MFN 06-067

**Subject: Partial Response to NRC Request for Additional Information Letter
No. 6 for the ESBWR Design Certification Application –
Instrumentation and Control Systems – RAI Number 7.2-3**

**Partial Response to NRC Request for Additional Information
Letter No. 6 for the ESBWR Design Certification Application
Instrumentation and Control Systems - RAI Number 7.2-3**

Figure XX ESBWR E-DCIS (C63) - RPS/LDIS/ATWS SLCS SSLC - typical of four divisions

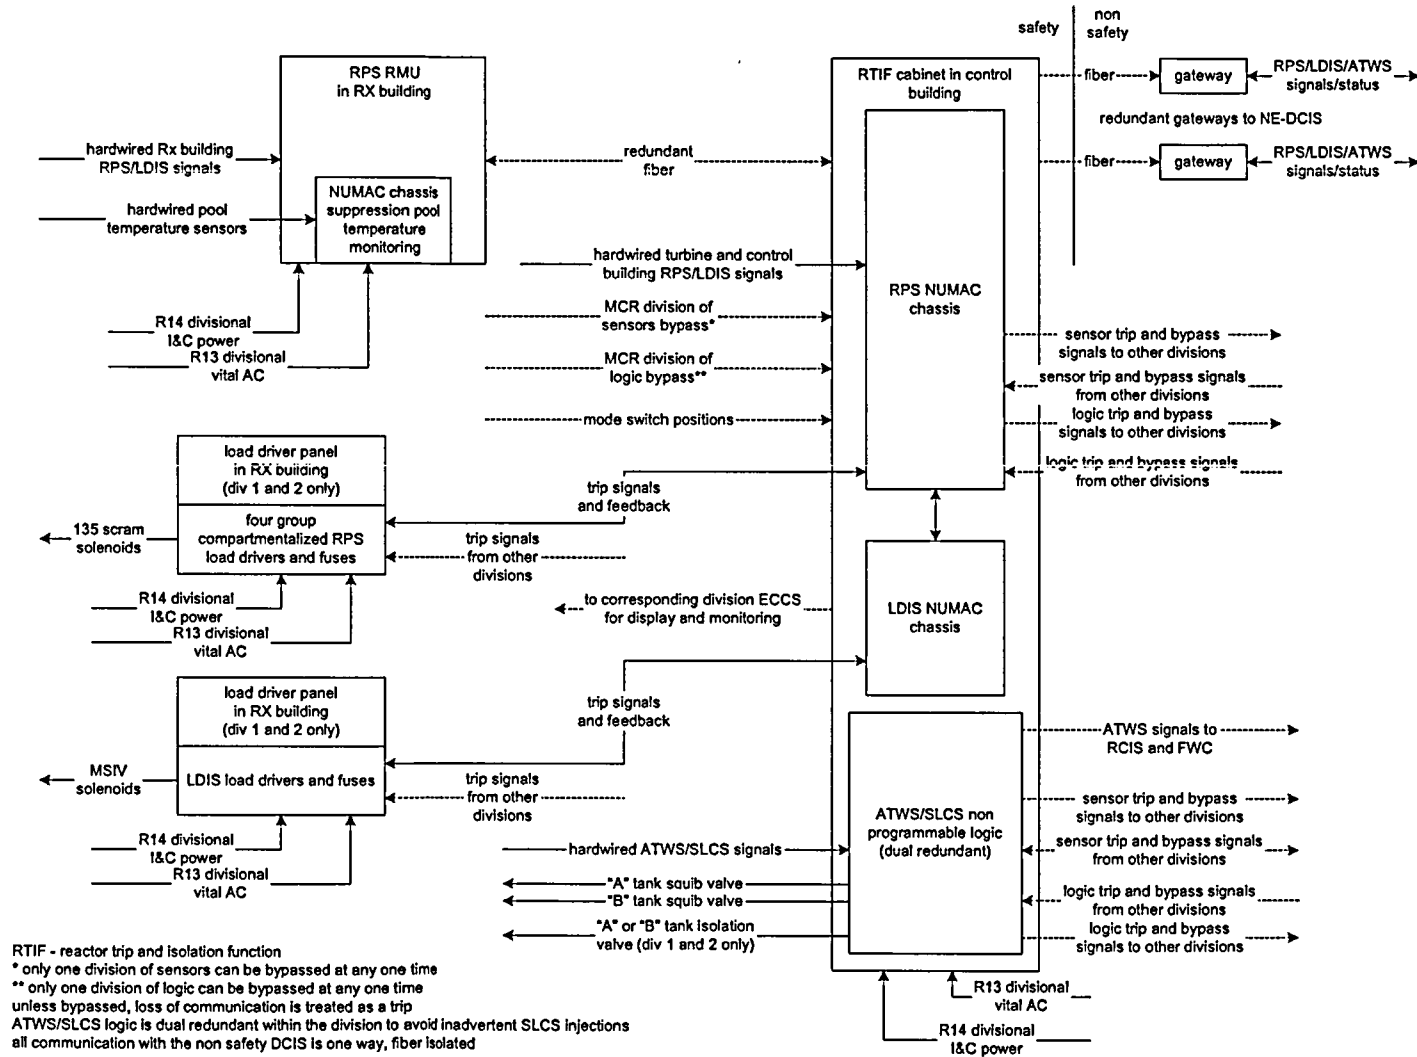
Provide detailed information and design basis on the RPS bypass provisions. The DCD states that the RPS includes two possible operator controlled bypasses. These are independently controlled by separate fiber optic "joystick" switches. Provide detailed information and the design basis of these bypass provisions.

The reactor protection system (RPS) is a hardware/software subfunction of safety system logic and control (SSLC) which is, in turn a subfunction of the essential distributed control and information system (E-DCIS); the general arrangement is shown in the attached Figure XX. The RPS controllers/logic are located in a cabinet (one per division in separate EDCIS rooms) that combines the RPS, LDIS (for MSIVs and drains only) and ATWS/SLCS functions; the cabinet is called the reactor trip and isolation function (RTIF) cabinet. Although all equipment located in the RTIF cabinet is appropriate for its respective division and everything in the cabinet is powered by the appropriate divisional power (R13, R14, and R16), the ATWS/SLCS function is segregated to a separate chassis in the cabinet and does not use programmable logic, which is different from the rest of the equipment in the cabinet.
